PROBLEM *Solver*[™] BULLETIN

Front Coil Spring Failure

2000-2007
Ford Focus

MOOG® Coil Spring 80170, 80172 and 81030

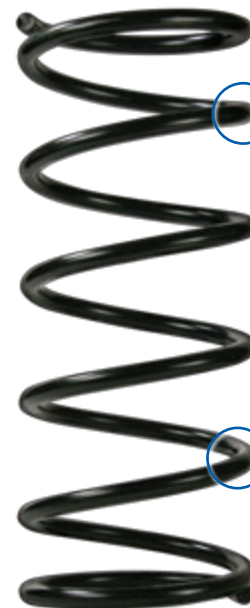
Front coil spring failure

Stress and corrosion can cause front coil springs to fracture and fail, resulting in suspension noise and sagging.

MOOG offers a replacement constant rate coil spring designed to provide more strength and durability:

- Larger diameter bar and additional coils reduce stress throughout the spring to combat fatigue.
- Improved coated material resists corrosion.
